MIL-D-23523D(SH)
AMENDMENT 2
23 February 1996

DEHYDRATOR, LOW PRESSURE AIR,
FOR SPECIAL APPLICATIONS

This amendment forms a part of Military Specification MIL-D-23523D(SH) dated 23 November 1987, and is approved for use by the Department of the Navy, and is available for use by all Departments and Agencies of the Department of Defense.

FIGURE 1

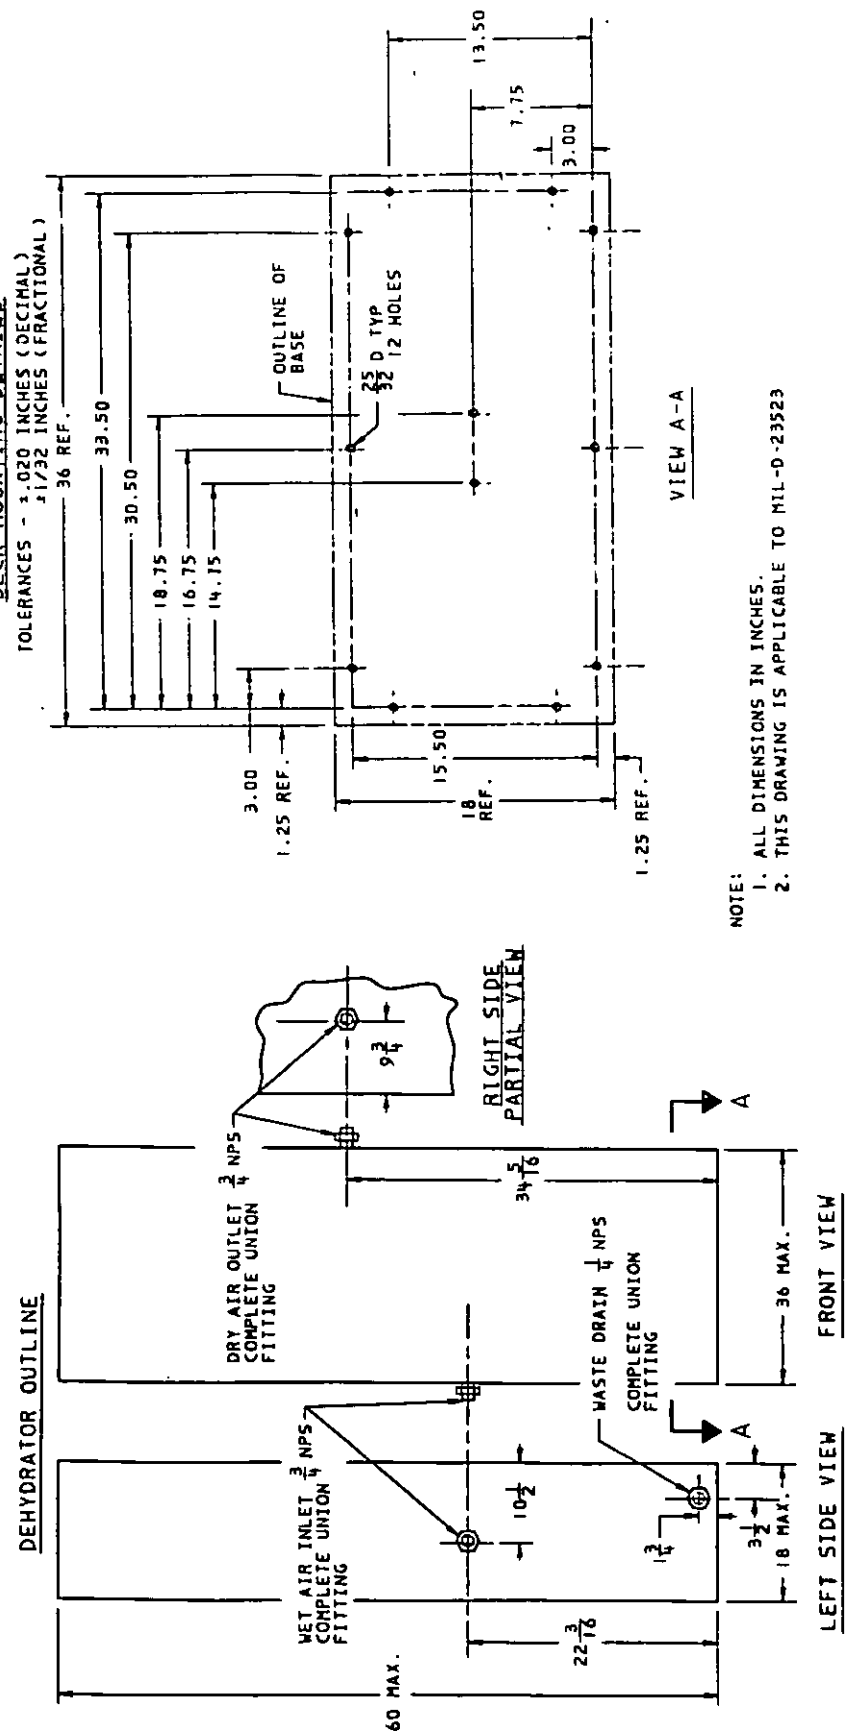
3.4 Delete second sentence and substitute, "Dehydrators shall be shipboard deck mounted and shall have mounting interface as detailed on figure 1."

3.8.2 Delete "piping and sizes" and substitute "piping, sizes and locations". Delete "as specified (6.2.1)" and substitute "as detailed in figure 1."

Add new page - FIGURE 1: - Insert the attached figure 1.
